To:	Arun District Council	From:	Envireau Water
Ref:	2449 Eric Wall Longacre GH&Res \ TN2 Query Response.docx	Pages:	5 + Figures + Appendices
Re:	Glasshouse and reservoir development, Maypole Lane, Yapton (Y/92/15/PL)	Date:	23/01/19

Following submission of TN1, Arun District Council raised 14 comments regarding the proposals in an email dated 7/12/2018. The response to these comments is provided in the following section. This technical note (TN2) should be read in conjunction with TN1.

2 RESPONSE TO COMMENTS

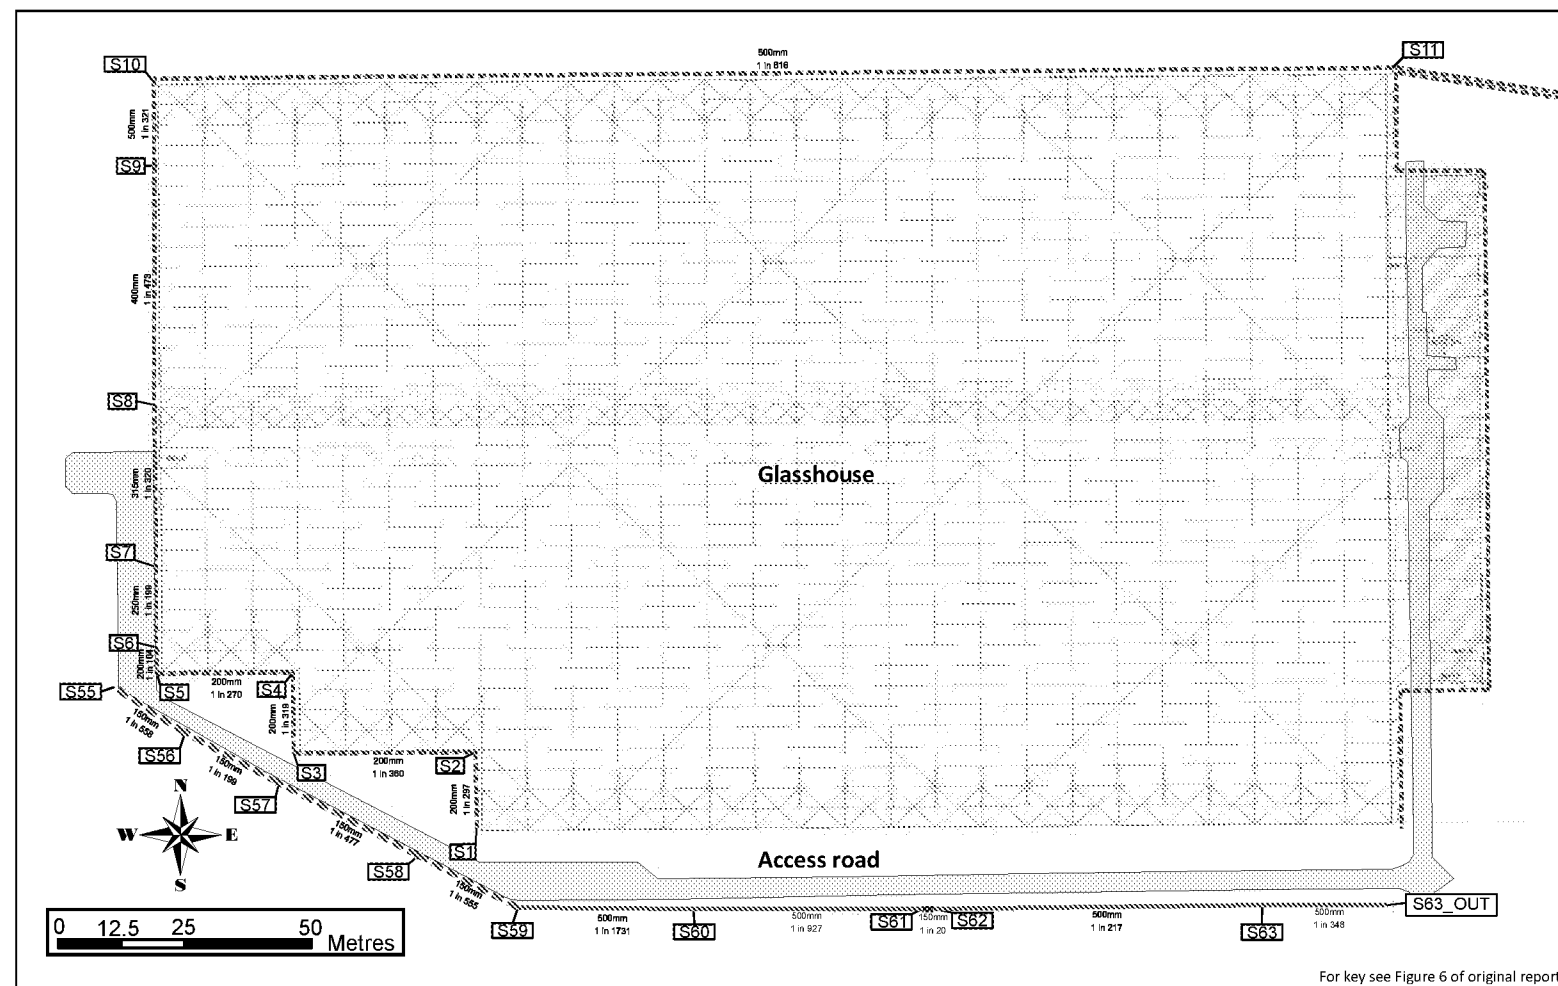
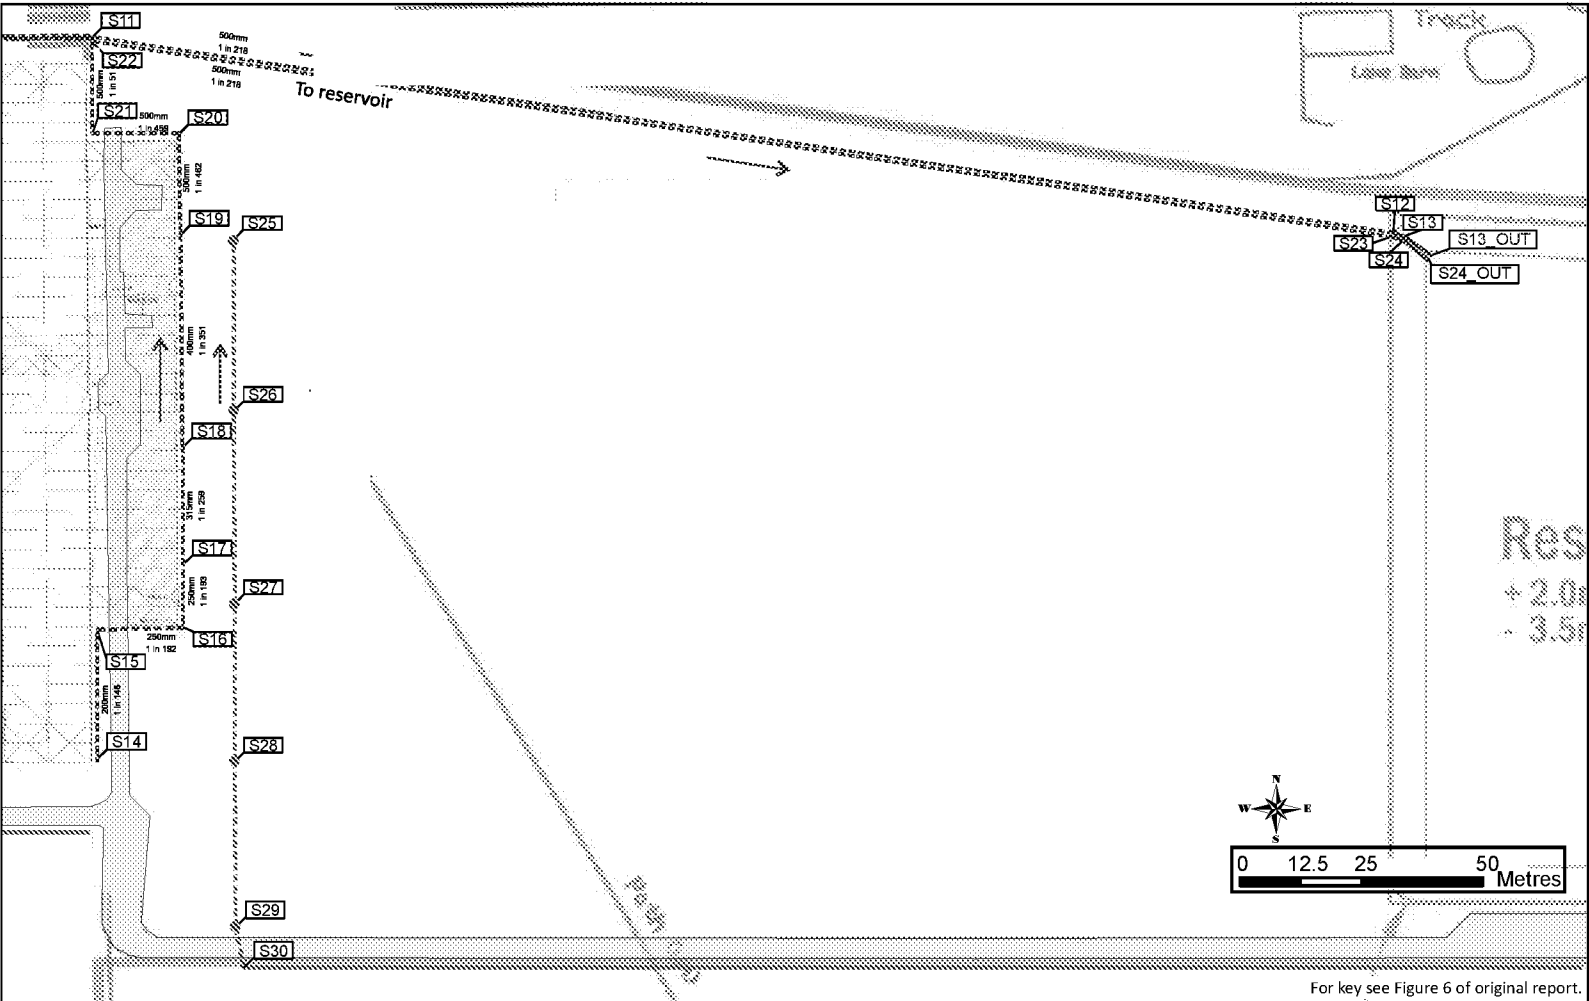
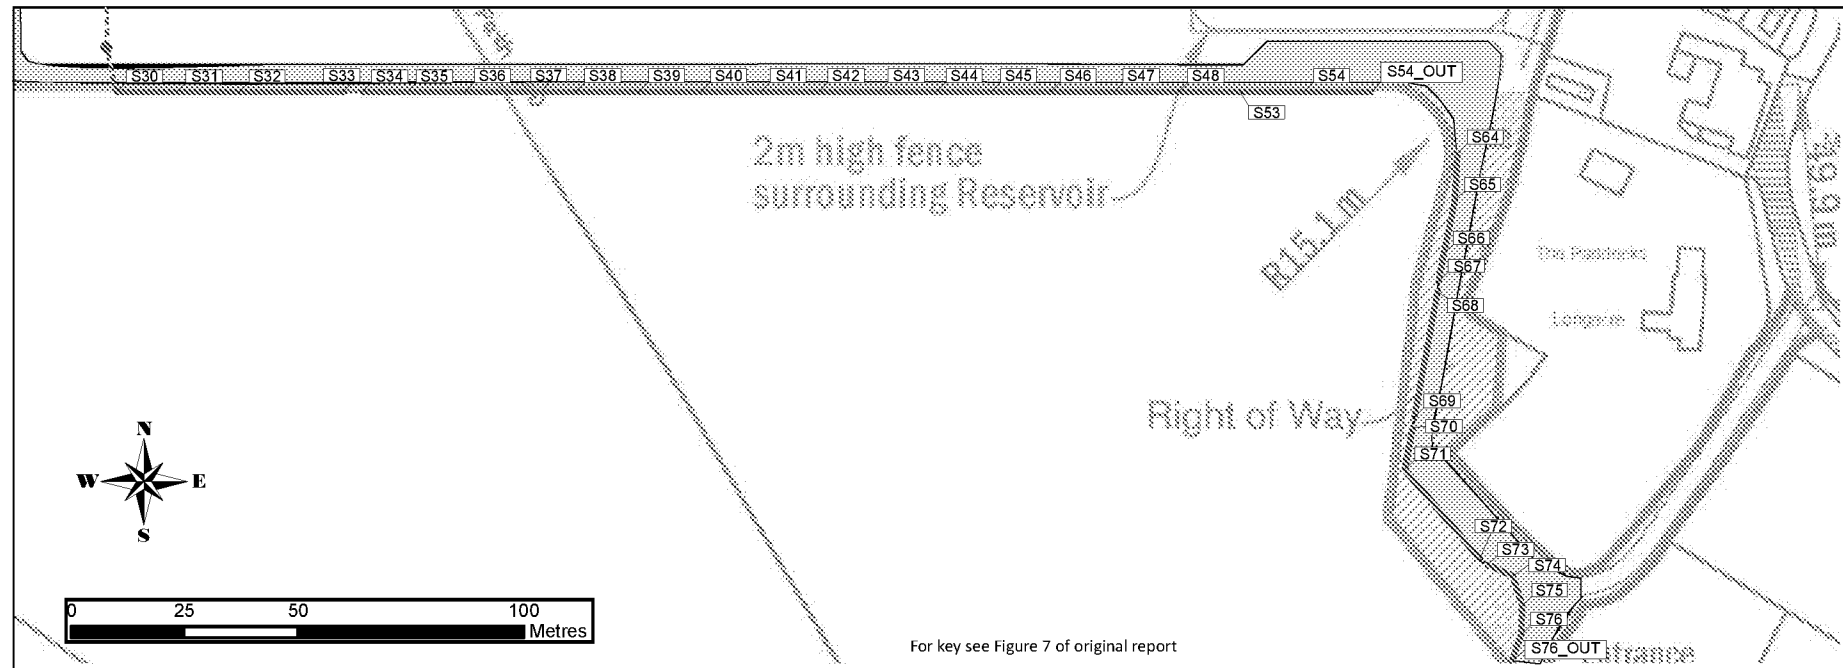
2.6 *You are proposing an overflow at 8.0m to take water to the infiltration swales. What is the depth of water for the 1 in 100 year plus climate change event above that used for irrigation storage?*

However, the previously proposed overflow from the reservoir to the swales will no longer be incorporated. The revised model drainage plan for the eastern section of the Site is provided in TN2 Figure 3.

TN1 - Section 2.4.3 provides the results for a modelling scenario for a high level outflow (for events greater than a 1 in 100 year return period) from the reservoir to the swale system. Based on the January 2019 infiltration testing, the design has been revised and **NO** overflow from the reservoir will occur.

APPENDIX A
JANUARY 2019 INFILTRATION TEST RESULTS

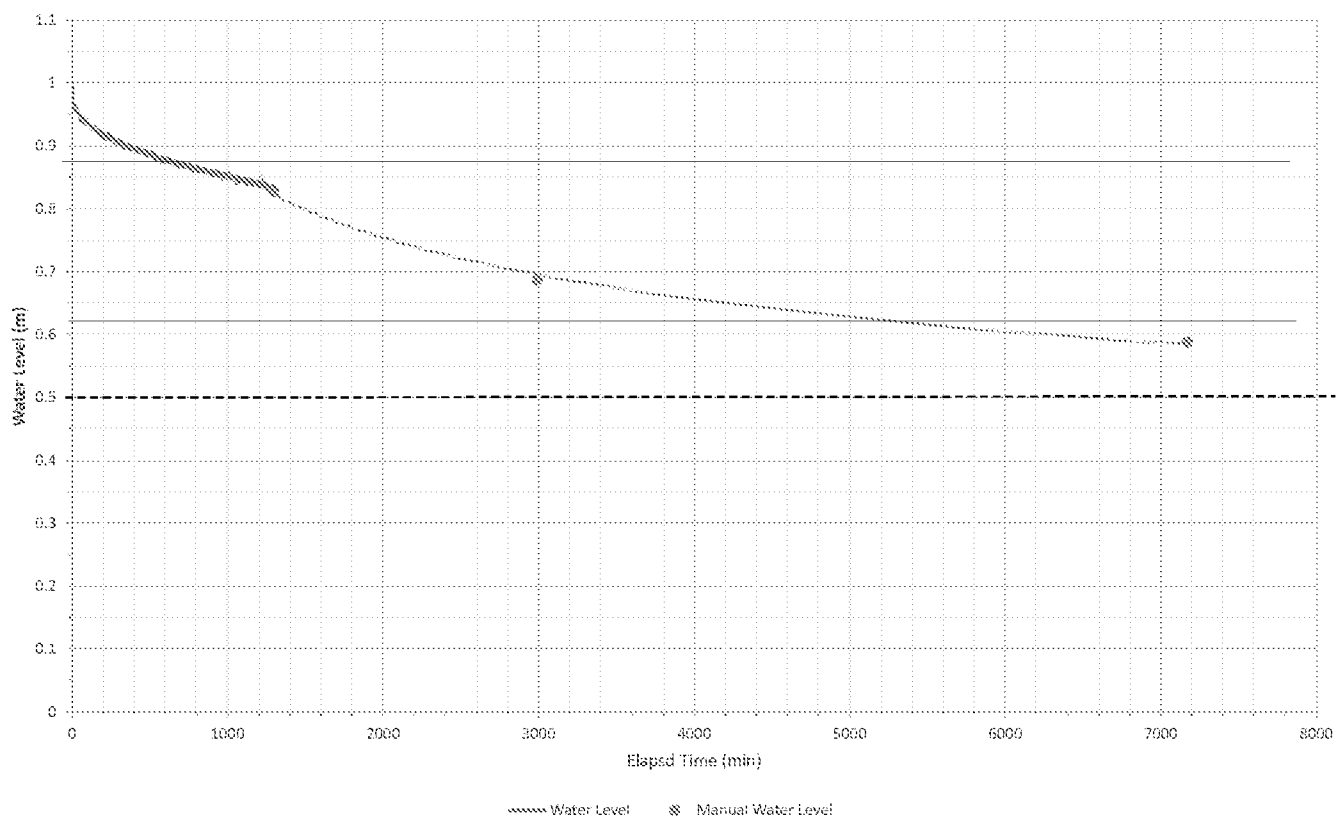
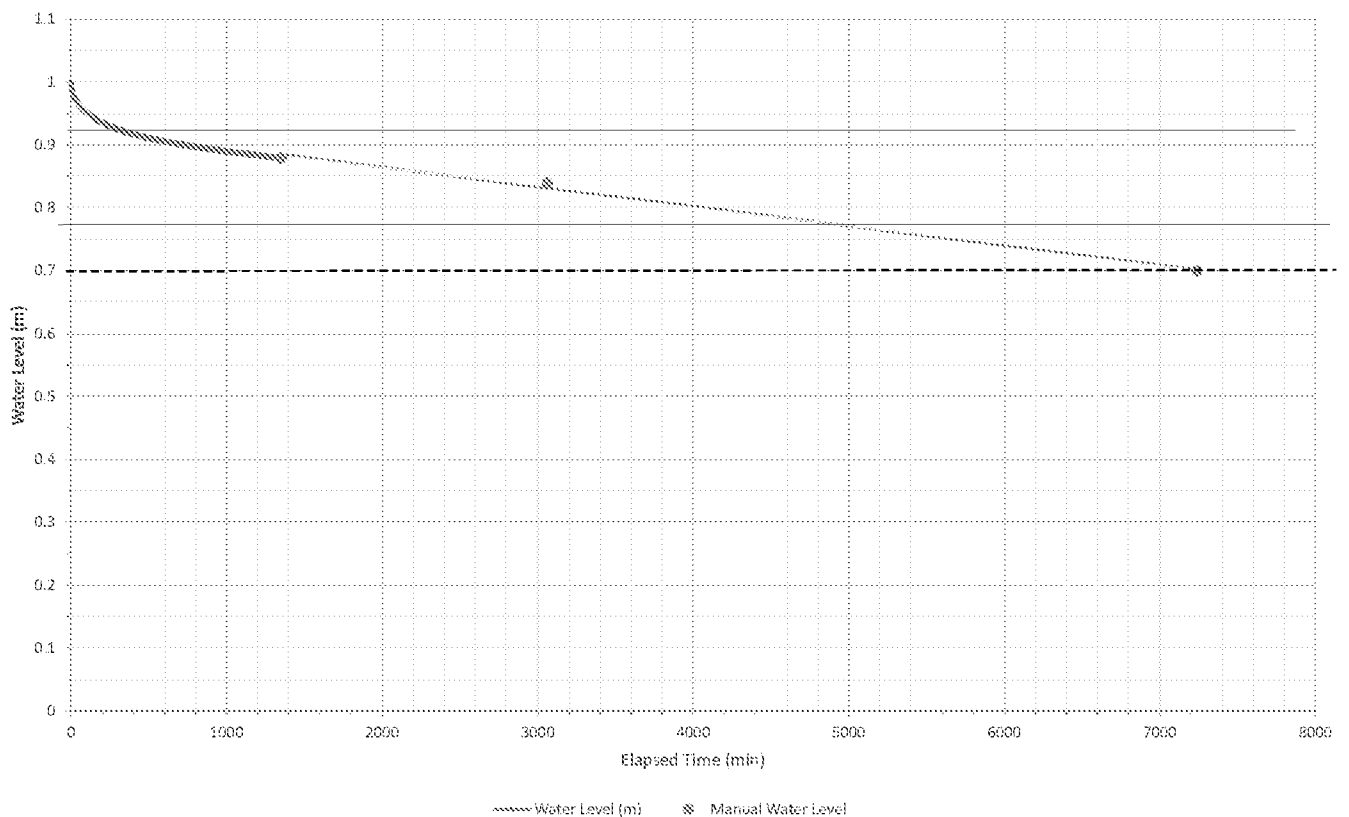
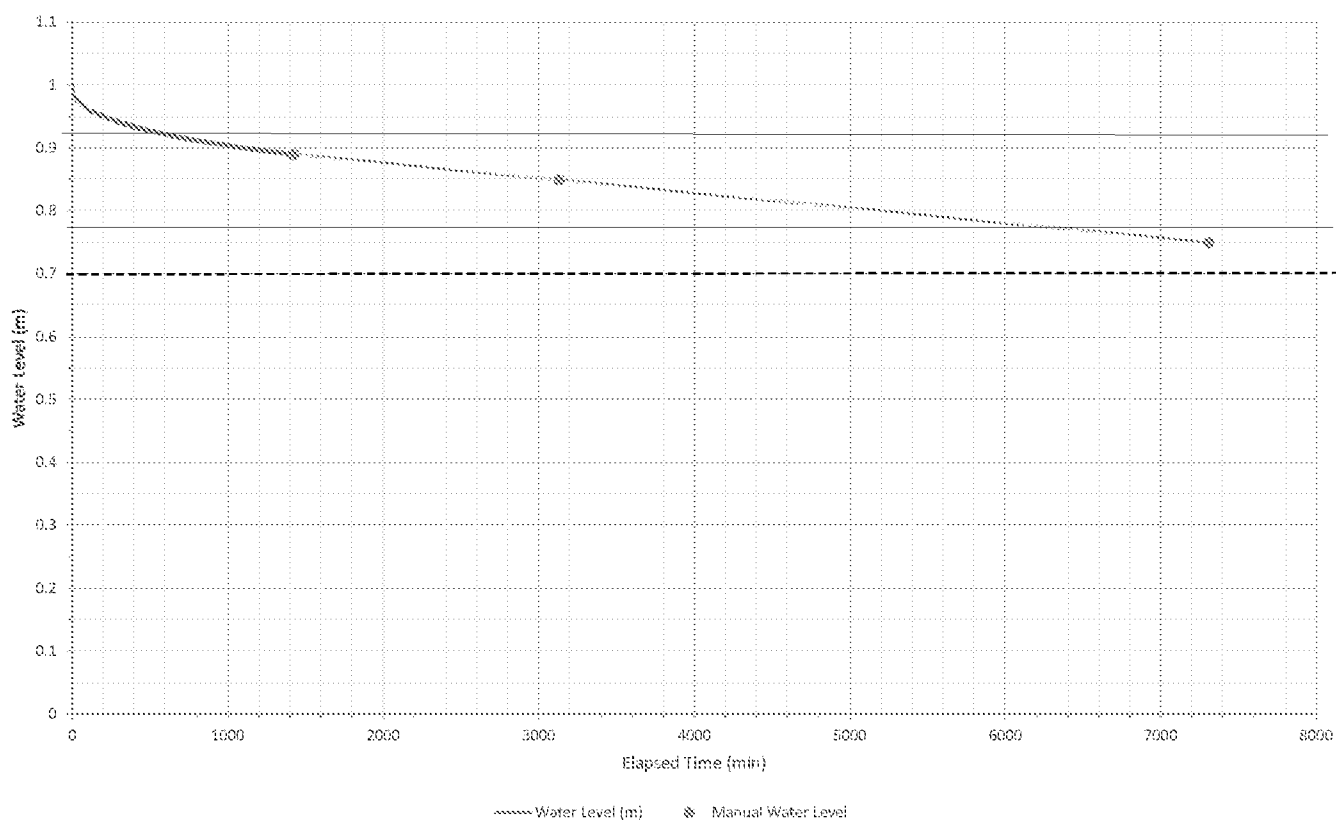
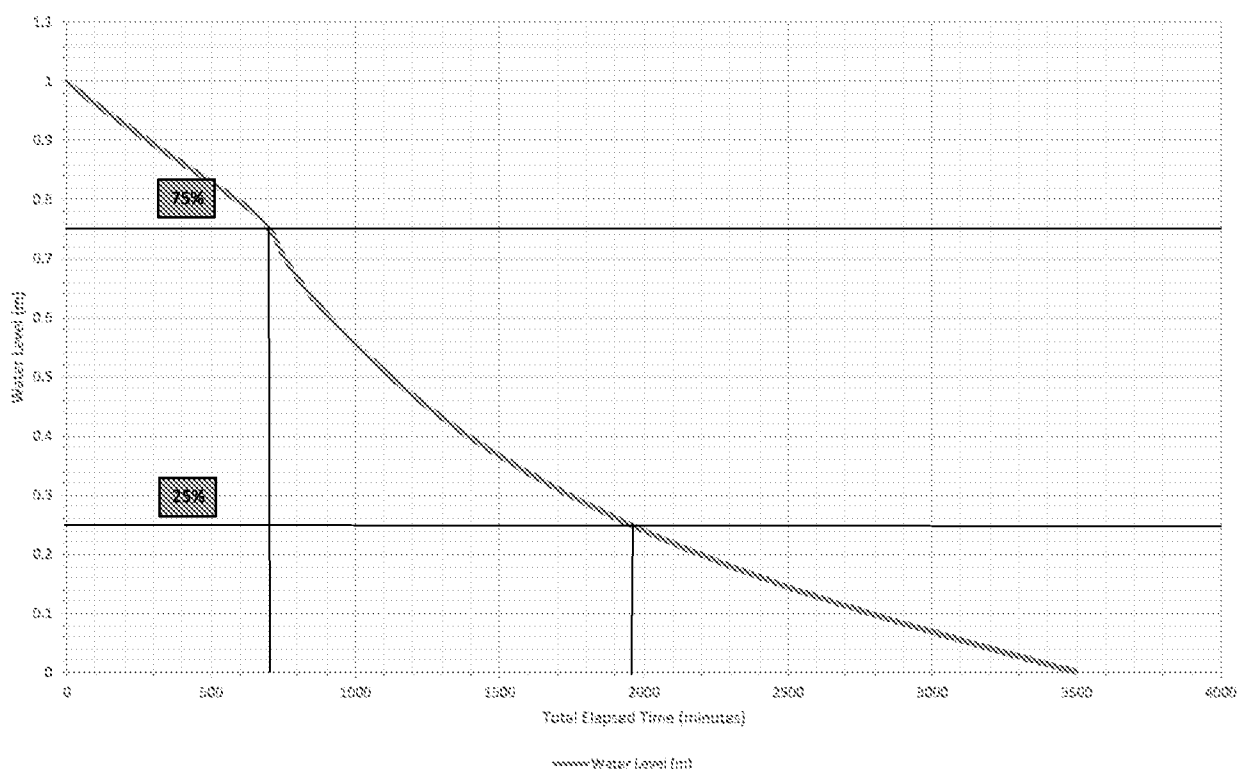
2.1 *Infiltration rates are also better than we would expect in this area. When were the infiltration tests completed? Infiltration testing needs to be completed within the winter. And were three successive tests completed at each location?*

Three tests were conducted at TPS D, producing an infiltration rate of 1.62×10^{-6} m/s (Appendix A). This is an order of magnitude less than the September 2018 test undertaken at TPS3A.

Testing of the other January 2019 test pits were undertaken (Appendix A); however, these pits did not drain fully after 5 days on a single test (estimated infiltration rate based on manipulation of data recorded for the single test is c. 3.48×10^{-7} to 2.32×10^{-7} m/s).

L-Bloc® / 1.2m / Reinforced

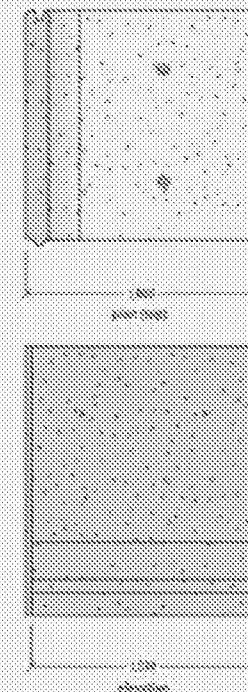
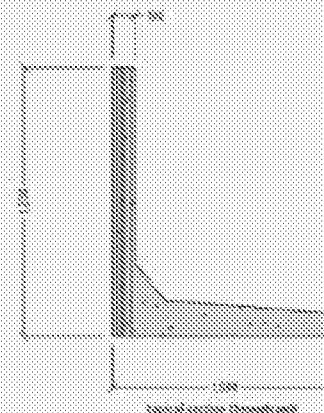
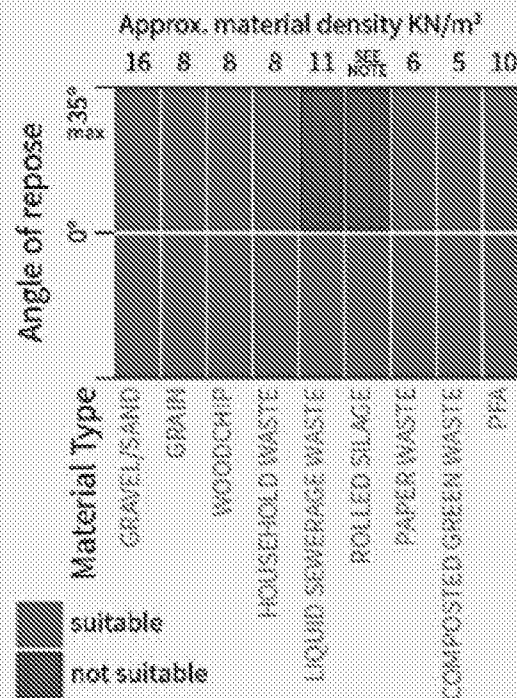
2.12 *Please provide further details of the flood risk barrier.*

The barrier will be a series of 1.2m high L-blocks. All the blocks will be anchored down onto a concrete hardstanding. An example of an appropriate L-Block is provided in Appendix C. The blocks will be joined together by a suitable jointing compound such as Fosroc Thioflex 600 Gun or equivalent. The technical sheet for this compound is also provided in Appendix C.
